ADDENDUM NO. 3

FY25 Stormwater Improvements

City of Seminole

A. Sheet C8, Plan & Profile (Baywood Park Drive)

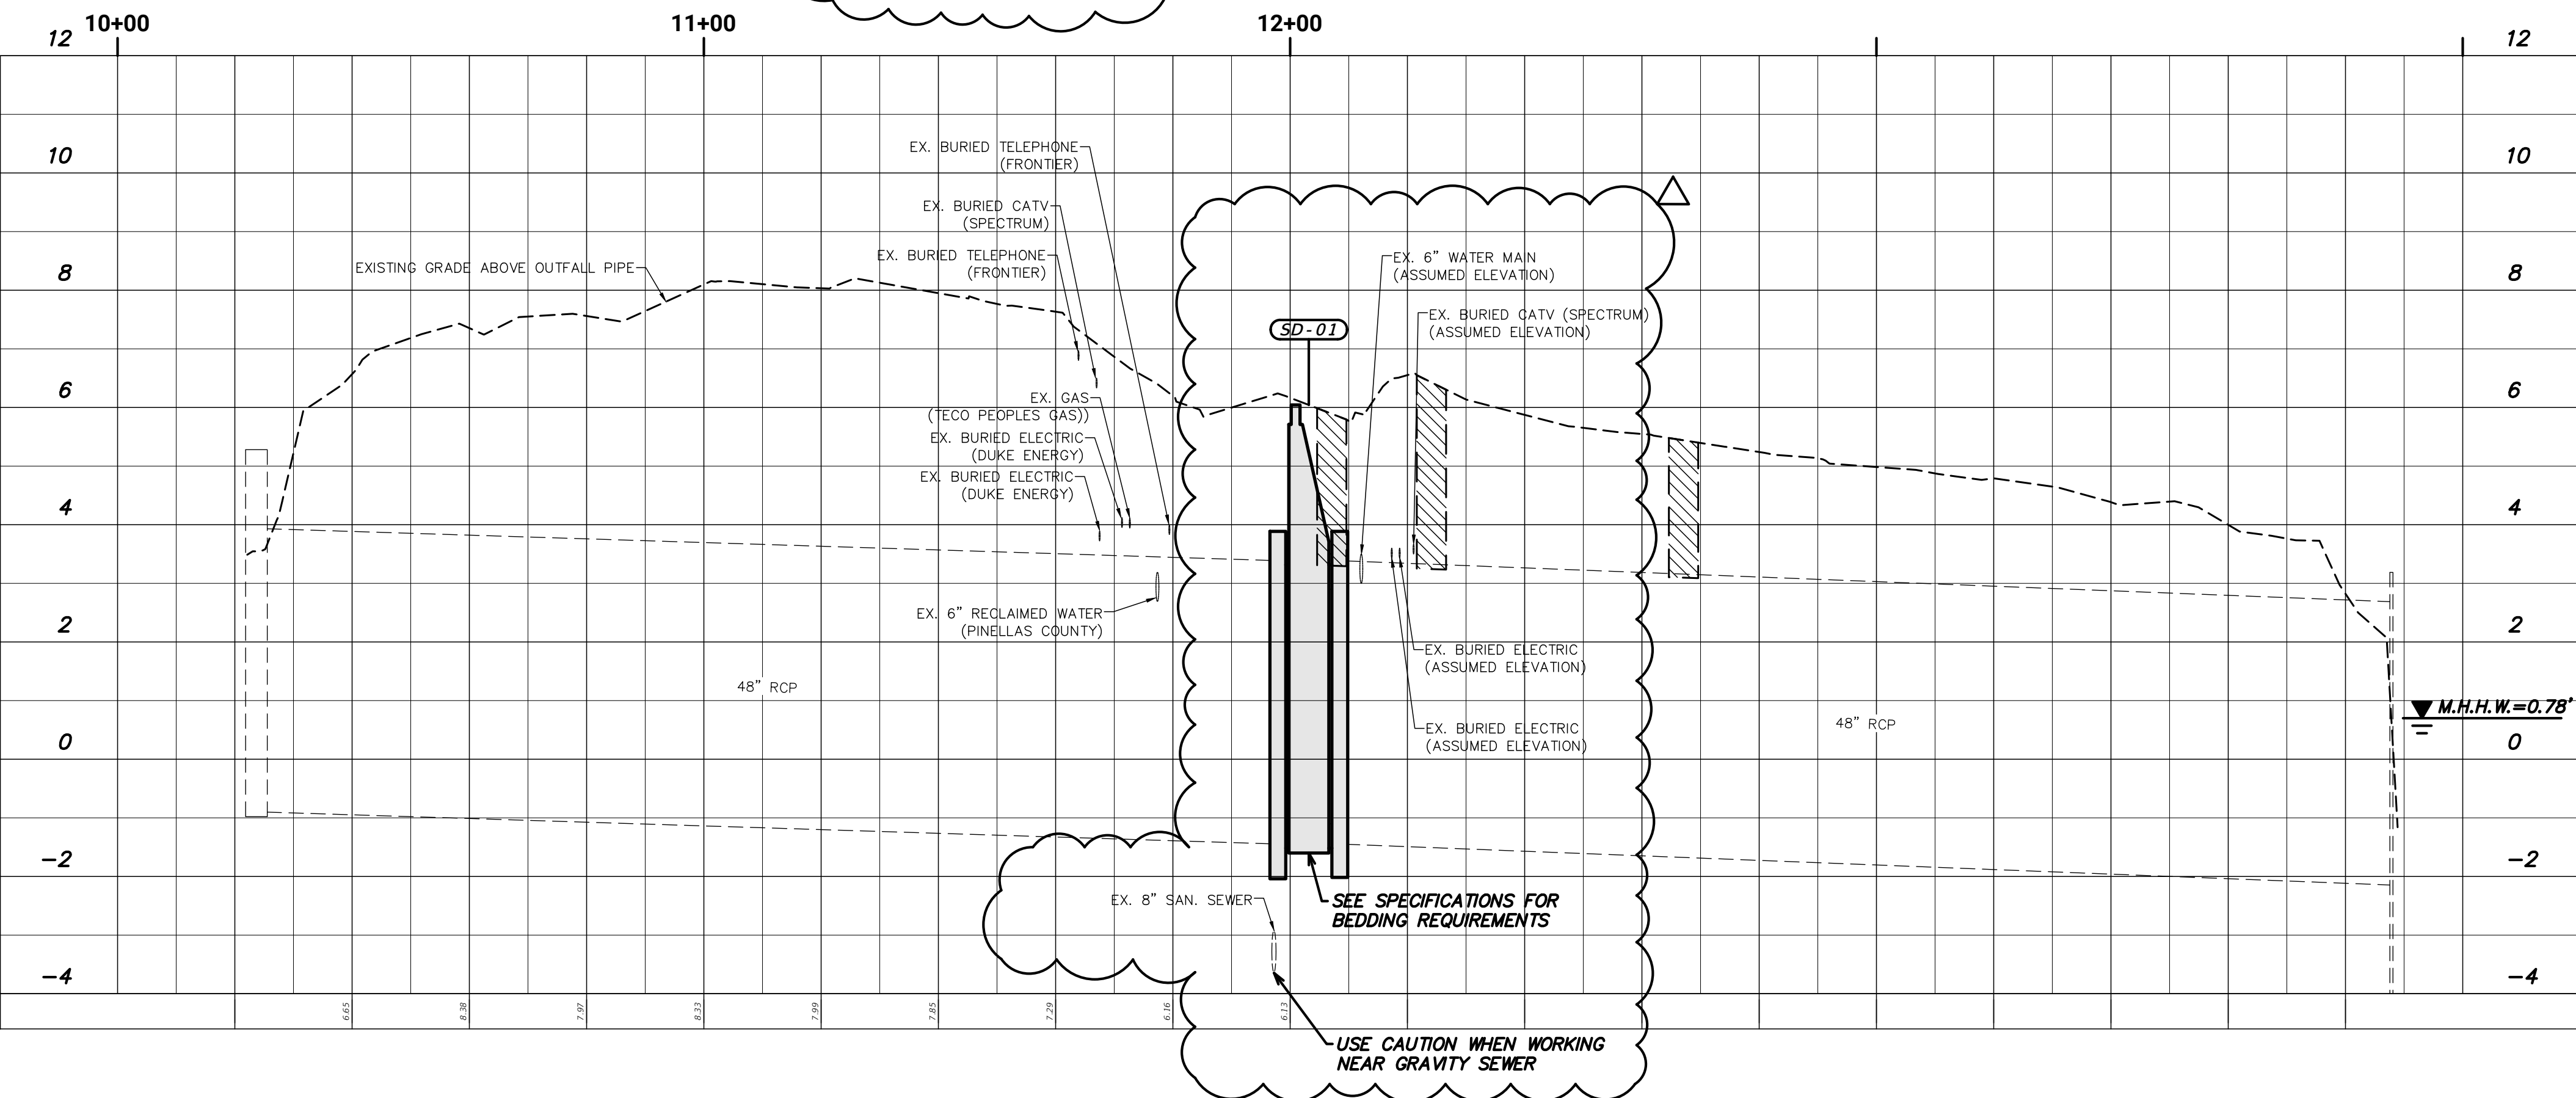
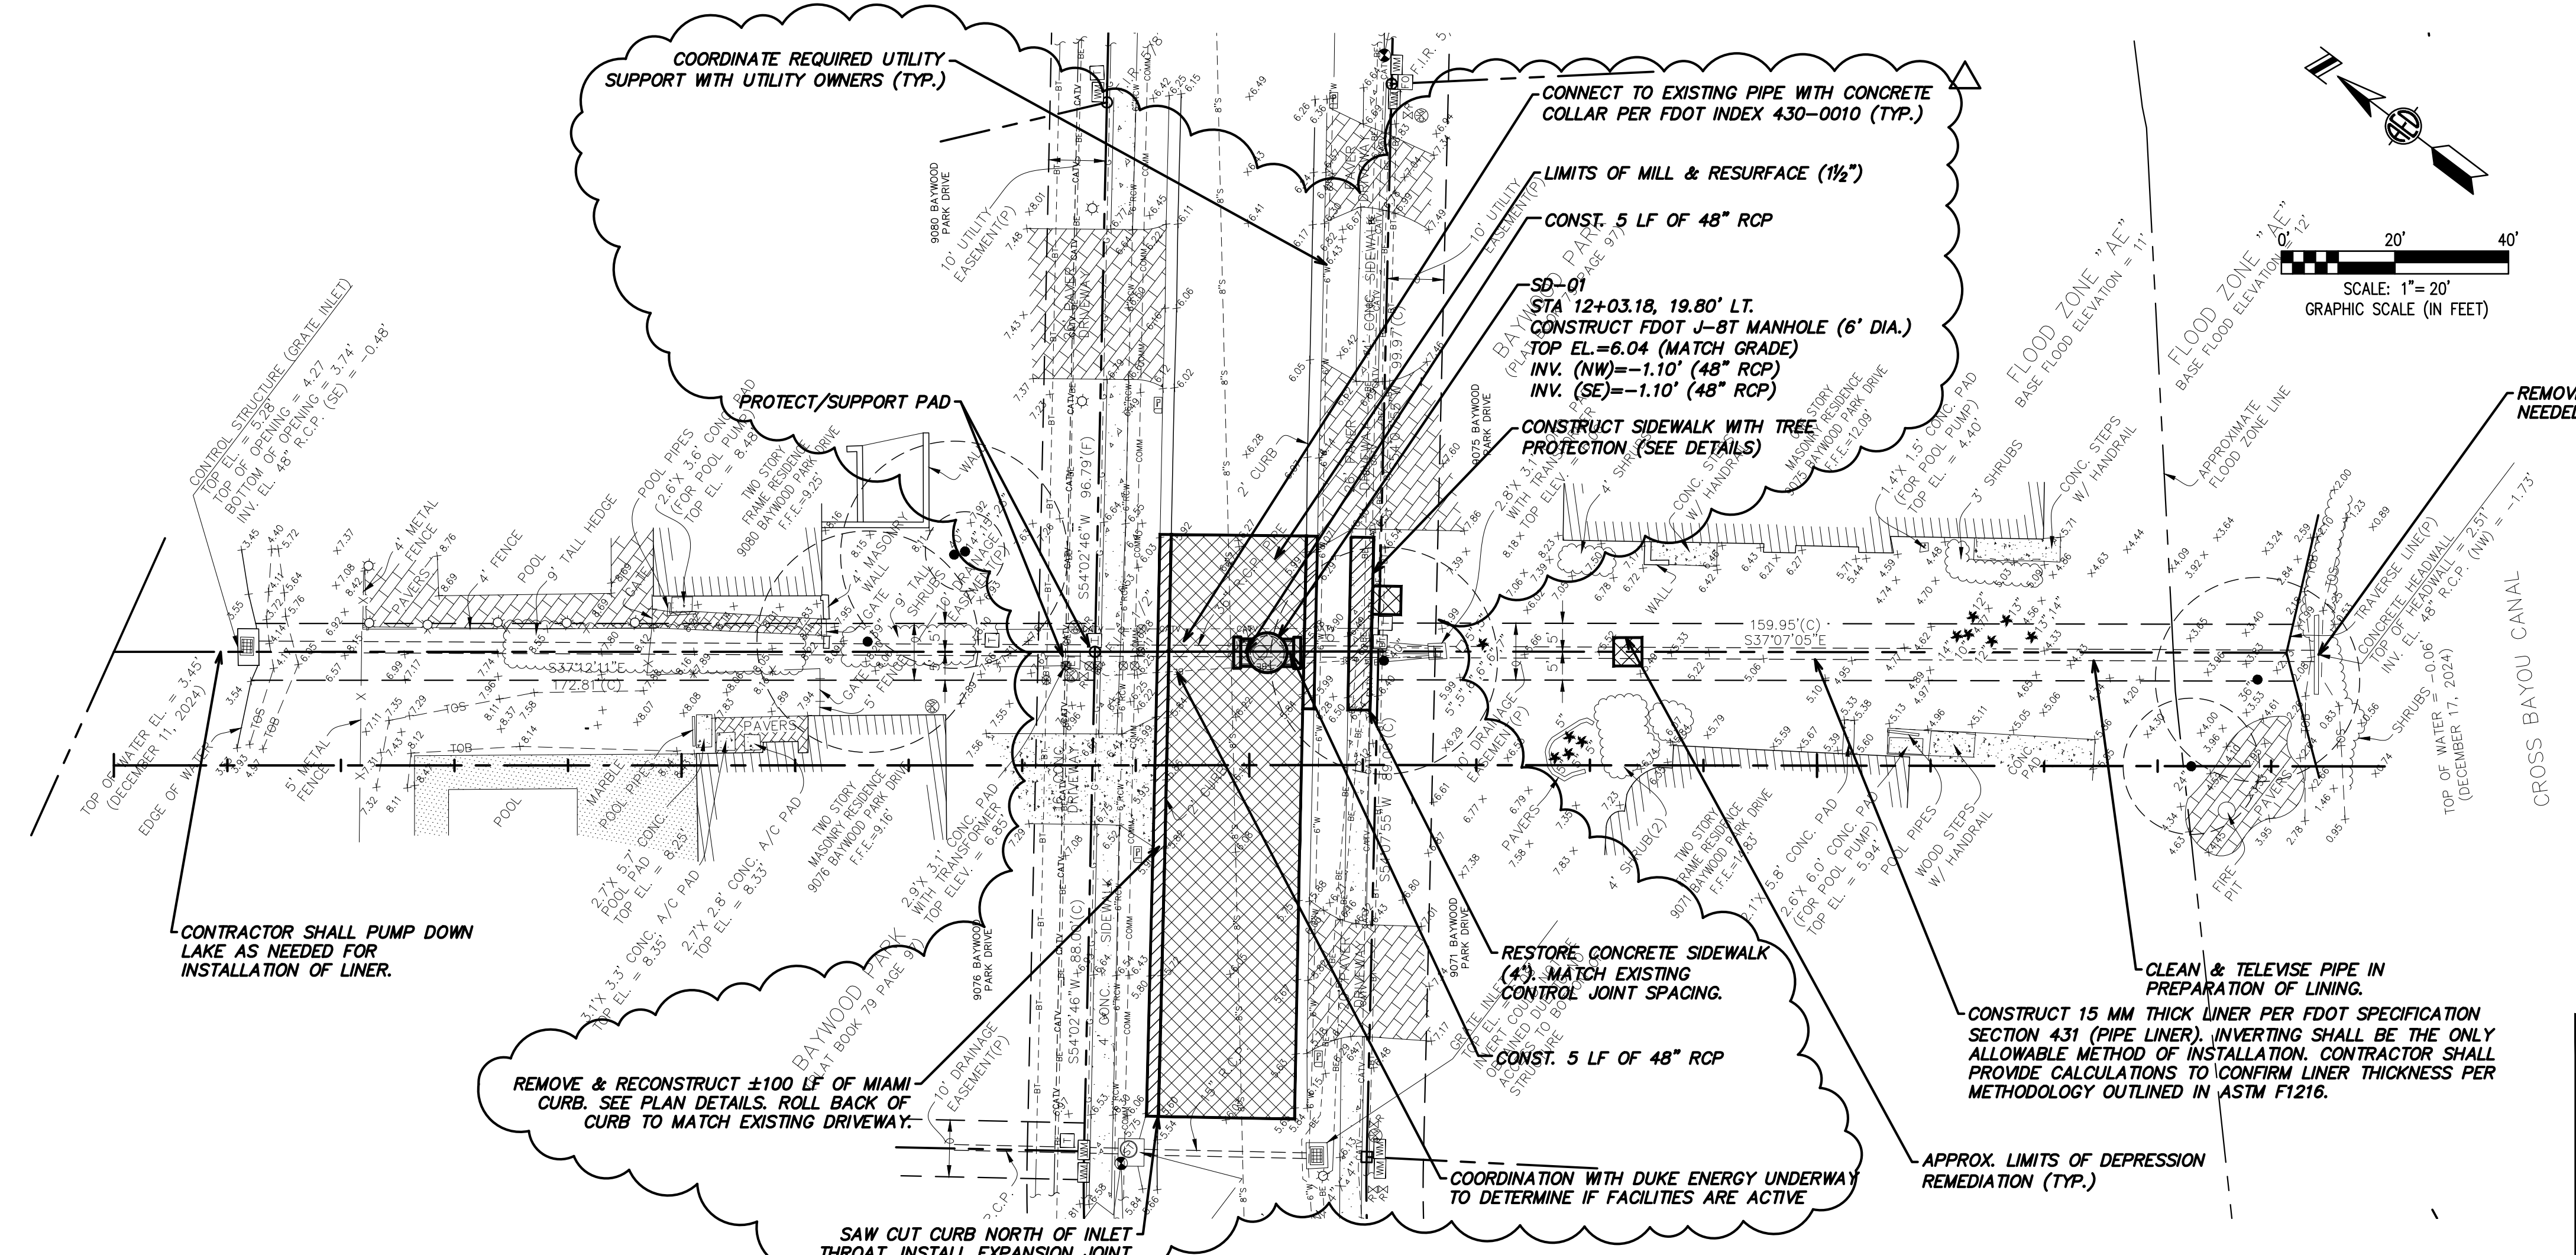
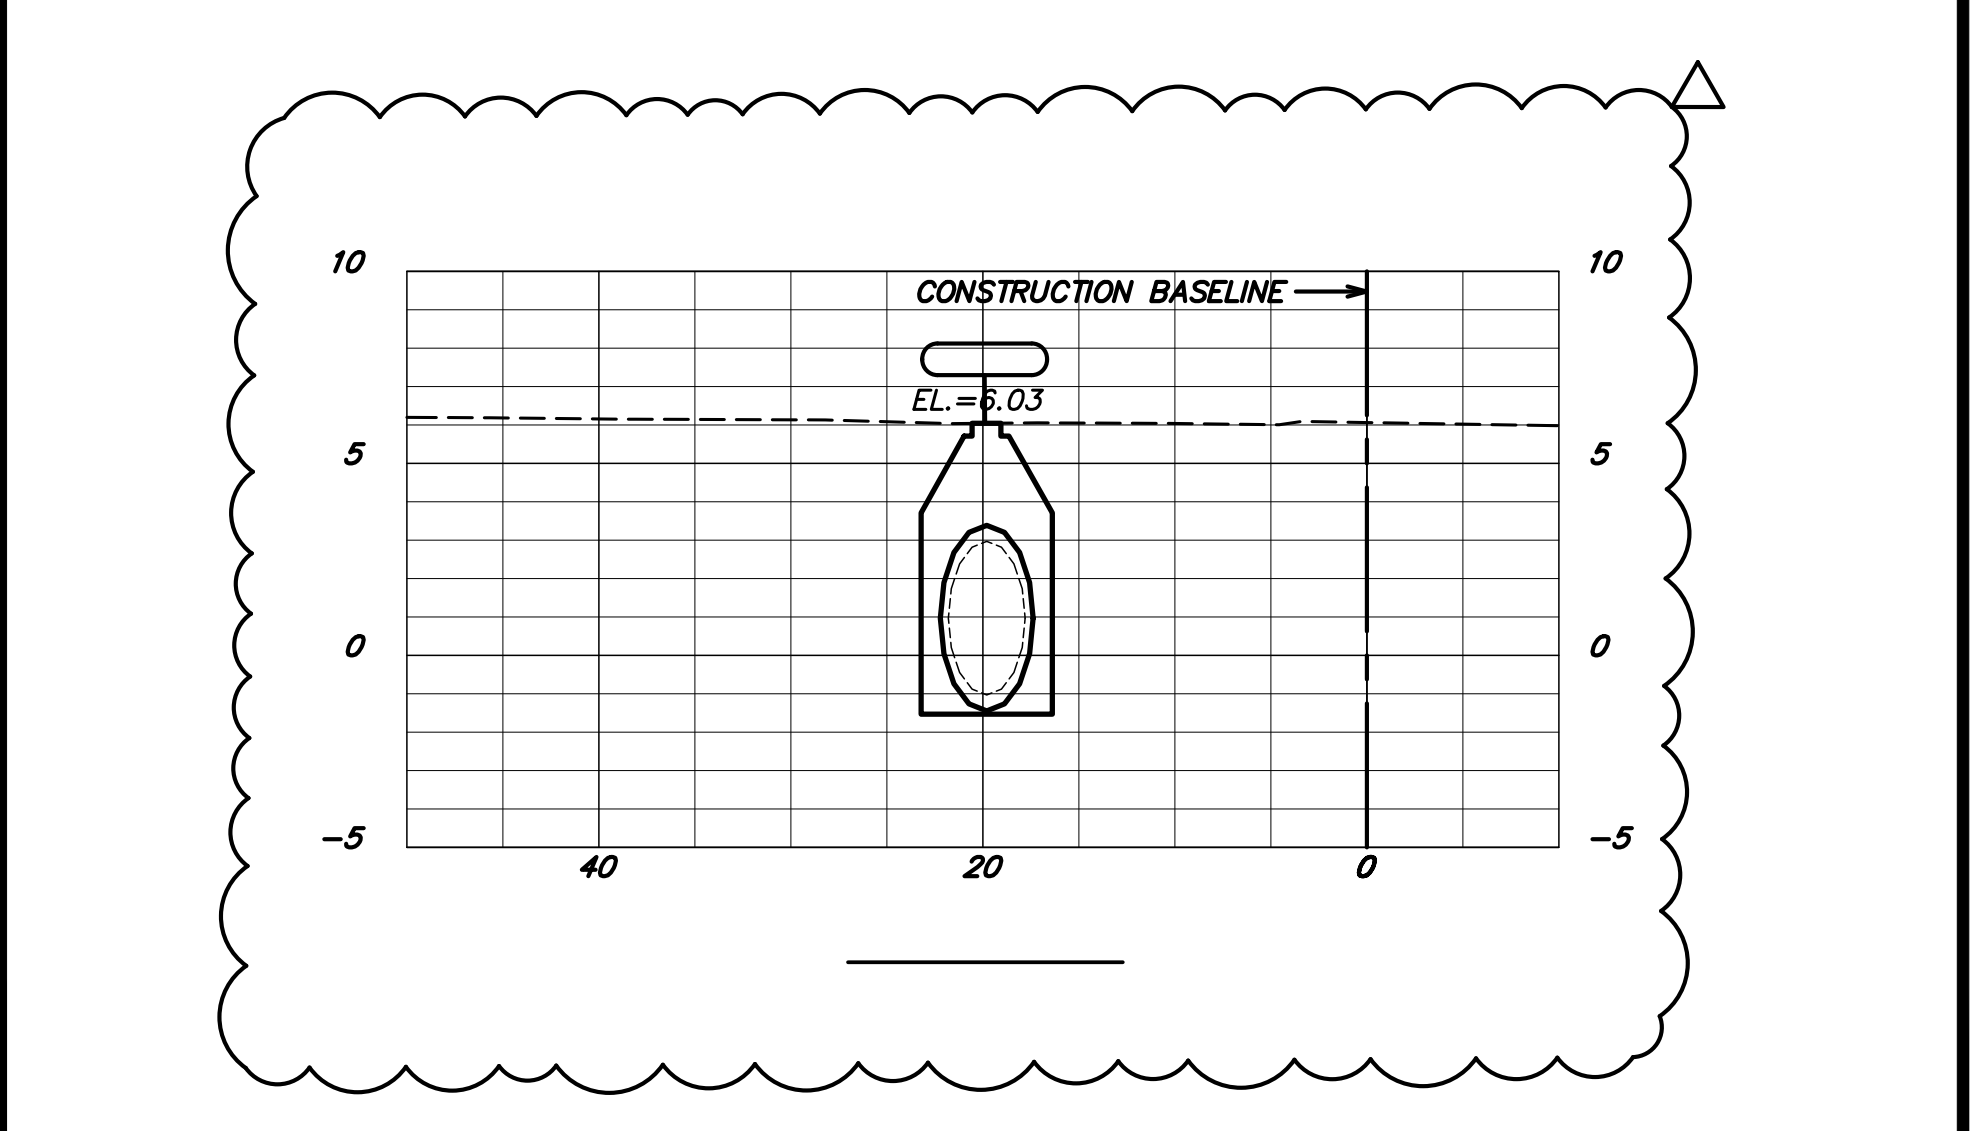
The location of the manhole structure has changed. The alignment of the sanitary sewer has been updated. A callout has been added regarding the buried electric line that crosses the street within the project area.
